**From:** Hanson, Paul: PC-BlgCtrl [paul.hanson@rbkc.gov.uk]  
**Sent:** 08/01/2014 15:06:14  
**To:** Hoban, John: PC-BlgCtrl [john.hoban@rbkc.gov.uk]  
**Subject:** RE: Grenfell Tower, Grenfell Road, Refurbishment - Fire Strategy P2

The Building Regulations 2010 [as amended]  
Grenfell Tower, Grenfell Road. London. W11.

**Subject:** Grenfell Tower - Smoke exhaust LFB submission.

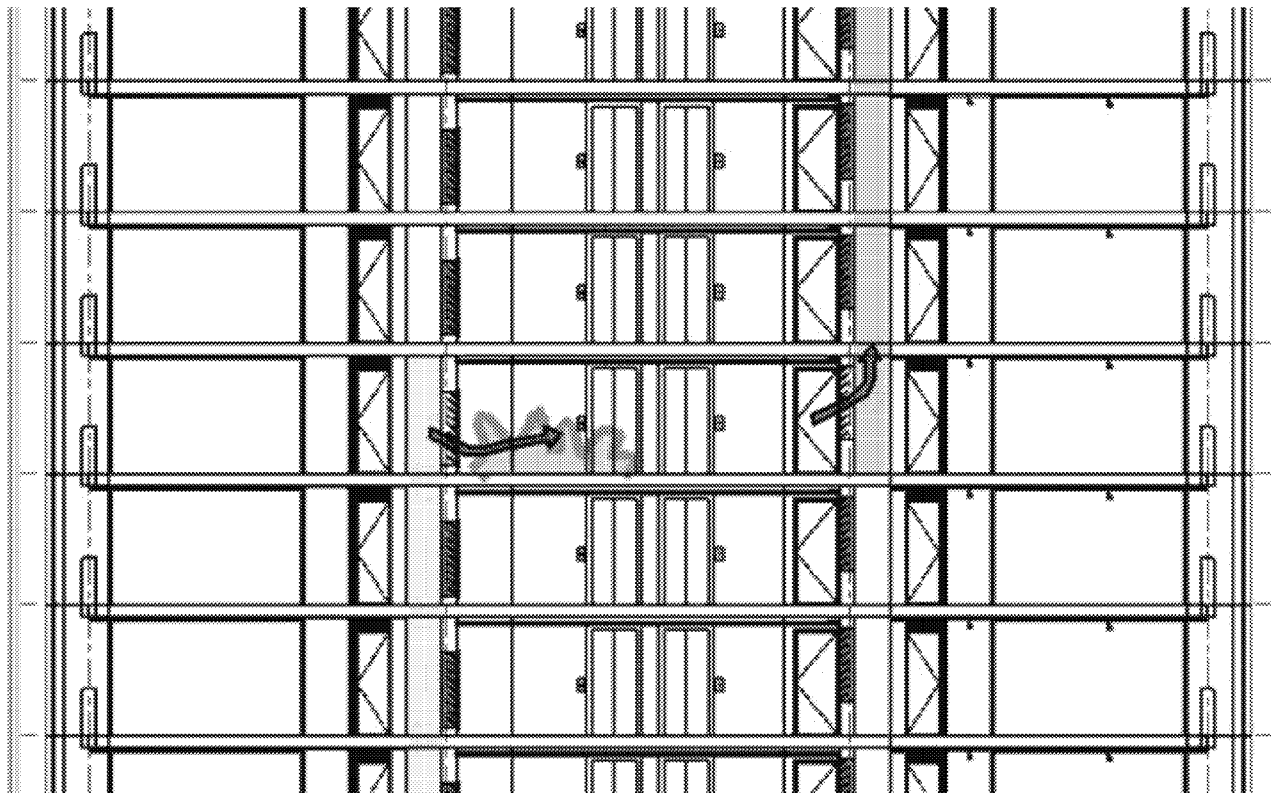
2. Some diagrams would be useful. I have attached our schematic drawing and Studio E have provided the visual representation below.
